NUCLEAR ENERGY INSTITUTE

April 26, 2001

Comments on
NUREG-1738 Technical Study of Spent Fuel Pool Accident Risk at
Decommissioning Nuclear Power Plants

Figure 1

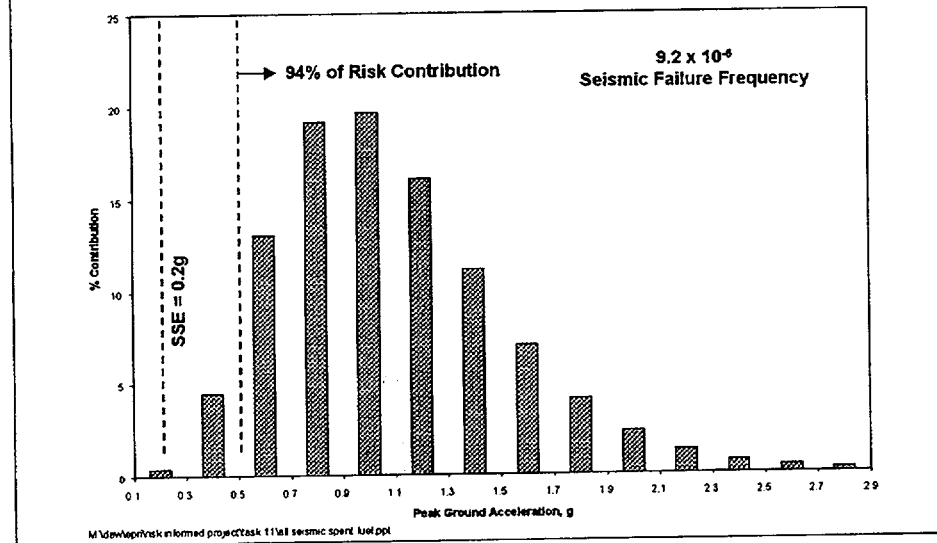
The staff extended LLNL seismic hazard curves beyond the return periods typically used for evaluating seismic risk at operating plants and requested that industry provide similar extensions for EPRI seismic hazard curves for the purpose of the spent fuel study. Figures 1-3 show the distribution of seismic risk across peak ground accelerations for spent fuel pools at three sites on the east coast. Note that for the Surry pool the 50th percentile of the annual probability of exceedance is 1 in a million years between peak ground accelerations of .5 and .6 g. In fact, the preponderance of the seismic risk is attributable to very low probability very large seismic events. For Surry an examination of Figure 3 reveals that 95% of the risk occurs at levels in excess of 0.5 g, 3 times the safe shutdown earthquake (SSE) for this plant; 60-plus% of the risk comes from seismic events exceeding 1.0g, 4-5 times the SSE for this plant.

Seismic failure frequency is calculated by integrating the product of the conditional probability of failure (called seismic fragility) and the frequency of occurrence of earthquakes over all values of peak ground acceleration. This procedure is called "convolution". For example, the mean seismic failure frequency of spent fuel pool structure at Robinson is calculated as 9.2×10^{-6} per year. This value includes contribution from different levels of ground acceleration. The above plot shows this contribution. For example, about 4 percent of the failure frequency is contributed by earthquakes in the range of 0.3g to 0.5g peak ground acceleration. It can be seen that 94 percent of the failure frequency comes from earthquakes with peak ground acceleration in excess of 0.5g. This situation arises from extrapolation of the hazard curves beyond the range of empirical evidence and the large uncertainty that the experts associate with the hazard at higher ground motion levels. It is comforting to observe that the spent fuel pool structure does not have seismic vulnerability at earthquakes less than 0.5 g peak ground acceleration and any upgrading of the structure beyond 0.5 g will not materially reduce the risk at higher levels. Further, the risk from higher levels comes mainly from extrapolations that are highly controversial.

Figure 4

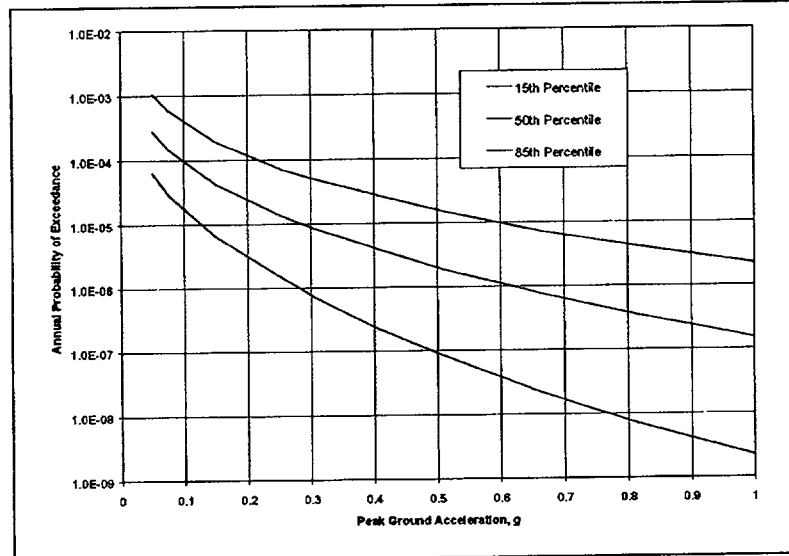
The ability to address seismic events that are not expected to occur is exacerbated by the fact that the tails of the curves are driven by uncertainty. For example, an examination of Figure 4 reveals that uncertainty increases from a factor of 10 in the realm of plausible earthquakes to a factor of 1600 at earthquakes of 1.0g. The diverging nature of the uncertainty curves means that real improvements in seismic capacity will be masked by uncertainty, as seismic events become larger, and more implausible. In addition, risk estimates are likely to be highly overly conservative at the high ground motion levels predicted for seismic events of this size.

This figure shows the seismic hazard curves for Surry. It is a plot of the annual probability of exceedance (called seismic hazard) of different levels of ground motion expressed in terms of peak ground acceleration. Different curves depict the uncertainty in the seismic hazard assessment obtained through a detailed expert elicitation process. The middle curve - median hazard curve - indicates that half of the experts judge the hazard to be below this level. The top curve - 85 percentile curve - shows that 85 percent of the experts judge the hazard at the site to be less than given by this curve. The bottom curve - 15 percentile curve - indicates that only 15 percent of the experts judge the hazard to be lower than given by this curve. At low peak ground acceleration values, the spread between the top and bottom curves is small since there is empirical data available for validation. At higher peak ground acceleration values, the spread is much wider reflecting the paucity of data and much reliance on expert opinion.

Probabilistic analyses should be performed because these analyses define the upper boundaries.¹ However, a lower limit based on curves that are truncated at certain very low return frequencies, should be employed for regulatory decision making regarding the need for protection requirements. For example, risk estimates for regulatory purposes based on return frequencies not exceeding E4 –E5 at the 50th percentile makes it clear to stakeholders that very low frequency events are outside the boundaries for practical decision making.
